National Electrical Safety Code
Interpretations
1991—1997 inclusive

**First Interim Collection
of the
National Electrical Safety Code
Interpretations**

National Electrical Safety Code Committee, ANSI C2

Fig IR 448-1

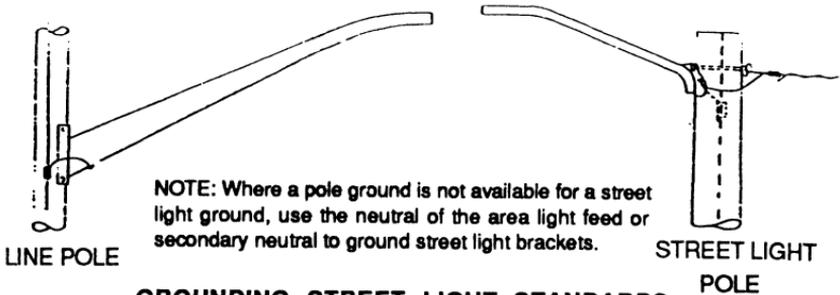
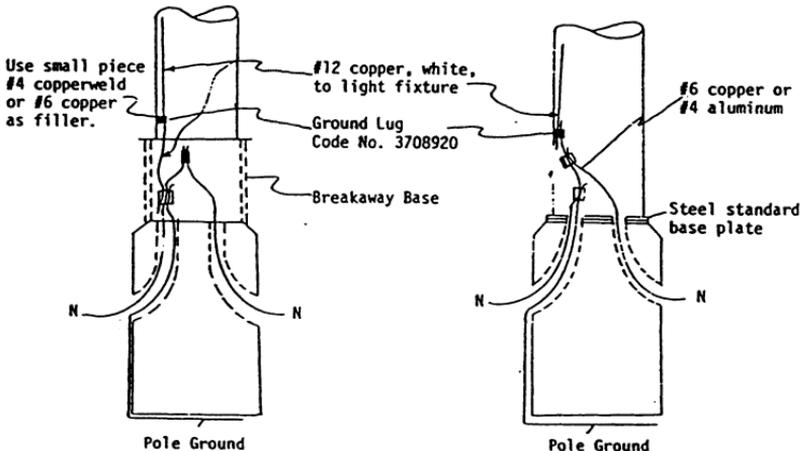
This company's specifications require using the grounded (neutral) conductor not only as the multiwire branch circuit conductor, but also as the equipment grounding conductor for bonding the noncurrent-carrying metal parts. Their standards experts quoted NESC Section 9 (92B1) as the source for requiring the use of the grounded conductor as a grounding conductor. I am enclosing a drawing of the company's requirements.

I feel that Section 92B(1) of the NESC agrees with the NEC by stating, "The grounding connections shall be made at the source, and at the line side of all service equipment." I would appreciate an interpretation of Section 9 of the NESC on using the grounded conductor as a grounding conductor for bonding the noncurrent-carrying metal parts in a situation similar to the one described.

To ensure that the breakaway base functions in the proper manner, the #12 ground conductor shall run through the grounding lug and connect to the neutral conductor. The grounding lug is too large for the #12 conductor and a small piece of #4 copperweld or #6 copper shall be used to fill the lug. See Street Light Chapter for complete wiring installation detail.

(In process)
